New Reactors Division

Step 4 Assessment of Chemistry for the UK Advanced Boiling Water Reactor

Assessment Report: ONR-NR-AR-17-020
Revision 0
December 2017

Figure 7: Comparison of Hitachi-GE and BWRVIA calculated chemistry parameters and ECP using Hitachi-GE dose rate data for the RPV bottom, initial core at BOC (Ref. 48)

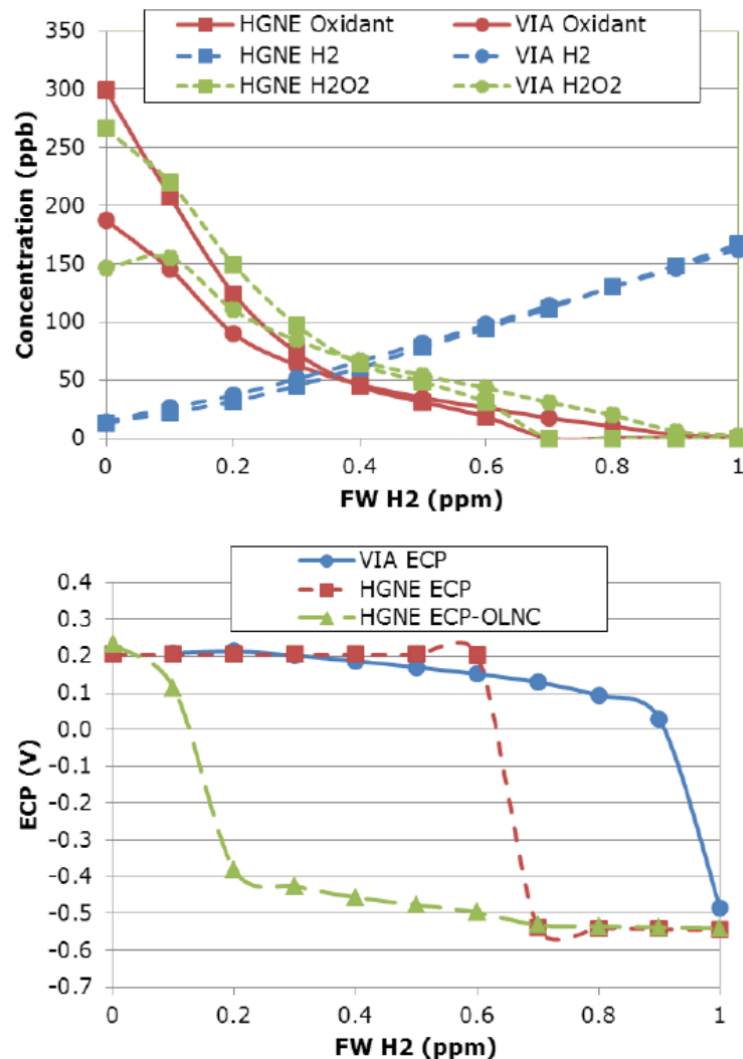
149. Figure 7 demonstrates both models predict similar chemistry in the bottom head of the RPV, although the BWRVIA data predicts that oxidant and hydrogen peroxide concentrations may be lower. Both data sets indicate UK ABWR will be responsive to HWC in the bottom head region of the RPV. However, looking at the predicted ECP values in isolation could lead to the conclusion that the bottom head region of the RPV may not be “protected” from SCC. The calculated ECP values indicate the BWRVIA model is less responsive to HWC in the bottom head of the RPV. However, BWRVIA does not calculate ECP values plants which inject platinum, where the ECP is largely determined by platinum deposited on the surfaces. In effect, BWRVIA under predicts the expected ECP under these conditions. The BWRVIA results are therefore not directly applicable for the planned UK ABWR operating chemistry in this region of the plant. Putting this to one side, these data do support Hitachi-GE’s claim that the operating chemistry provides SCC mitigation in the bottom head of the RPV.

150. This further reinforces the need for representative ECP and platinum deposition physical monitoring locations within the UK ABWR design (considered in more detail in Section 4.3.5.3 of my report). Figure 7 also further highlights the importance of understanding how flow patterns around the RPV may impact the calculated ECPs and how the RIPs are modelled in Hitachi-GE’s radiolysis calculations. **This has been captured as part of Assessment Finding, AF-ABWR-RC-01, above.**

Figure 8: Predicted SCC crack growth rates as a function of sulphate or chloride ion concentration (Ref. 45 EPRI)

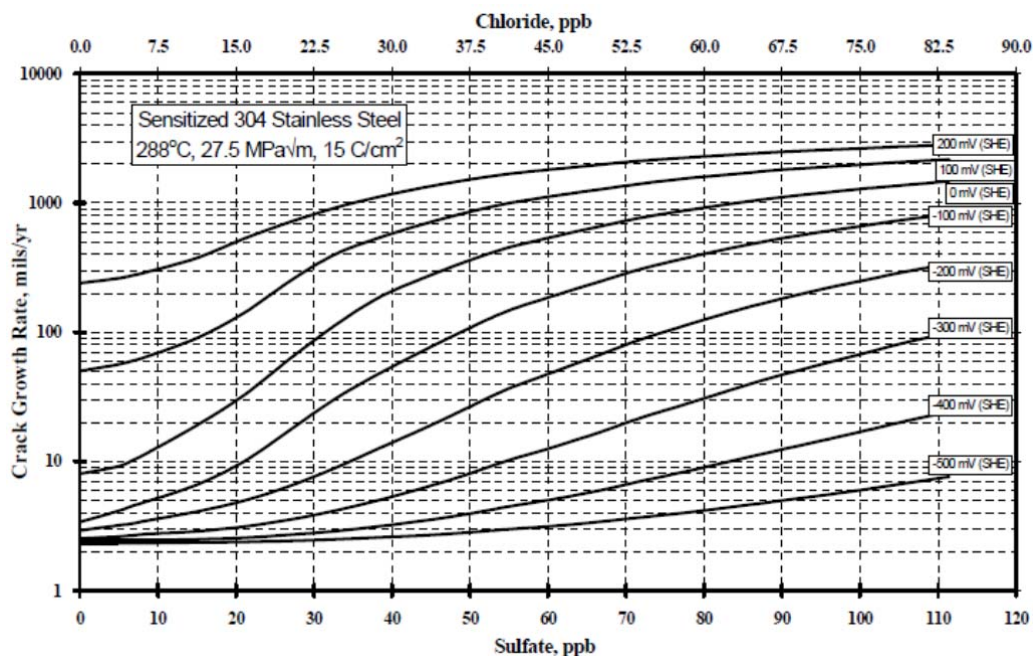
161. As also depicted in Figure 8, chloride has a similar detrimental impact on SCC rates. An important promoter of the impact of chloride is oxygen (or corrosion potential), which acts synergistically. With very low levels of oxygen (1 ppb), even extreme concentrations of chloride can be tolerated. While Figure 8 predicts a similar impact to sulphate, experimental testing concludes that the impact of chloride is in fact less (i.e.

Figure 13: Feedwater iron concentrations in “forward pumped” BWR plants with different alloy selections (Ref. 60)

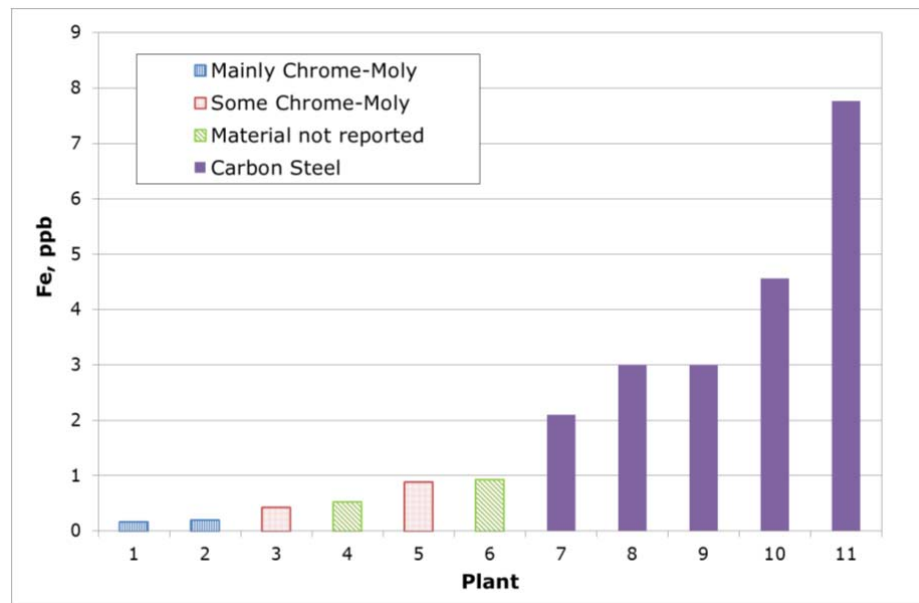
285. Figure 13 plots the feedwater iron concentrations for several BWR plants which are designed with forward pumped HDs. It shows the information as a function of the materials selected for the extraction drain, moisture separator and high pressure heater drain piping. These data clearly show forward pumped BWR plants operating with CS components in this part of the plant generally have higher concentrations of feedwater iron. During GDA, I also asked my TSCs to provide independent information (Ref. 43) on materials selection for the HD system for other BWRs. Based on the information provided, of those BWRs which were originally designed using CS for HD system main piping, primarily in response to FAC issues, many have gradually replaced large sections of piping with more corrosion resistant materials.

Figure 28: Worldwide BWR fuel failure rates (Ref. 94).

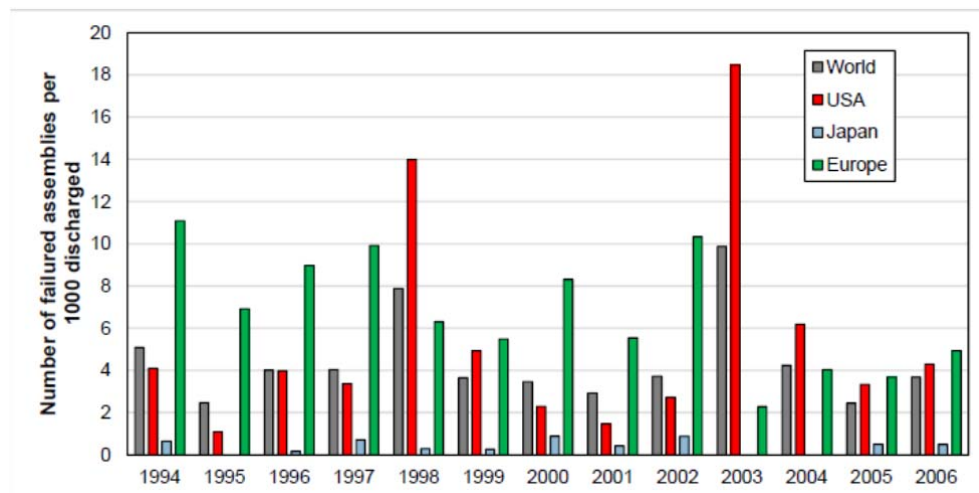
518. Data presented in Figure 28 does not distinguish between fuel failure mechanisms, but the trend clearly points towards the fact that BWR fuel reliability has increased significantly in recent times. Ref. 95 where Figure 28 is reproduced from does however provide a further breakdown of the fuel failure data, by mechanism. From 1990 and later, this information shows debris failures were consistently one of the top two leading causes of BWR fuel failures (Ref. 94). I am therefore satisfied with Hitachi-GE's overarching claim that chemistry is largely no longer implicated in modern day BWR fuel failure events. This conclusion is also supported by the independent work performed by my TSC (Ref. 94).
519. As I mentioned earlier, the most recent and infamous chemistry-related BWR fuel failure events occurred at the US BWR plants, River Bend and Browns Ferry, during

the late 1990s and early 2000s, respectively. The overall impact of these events on BWR fuel failure rates is clear from Figure 28. Although I agree with Hitachi-GE's overarching conclusion that chemistry is no longer implicated in significant numbers of BWR fuel failures, the River Bend and Browns Ferry events serve as important reminders that adequate control over the operating chemistry must be maintained to avoid fuel reliability and/or failure events.
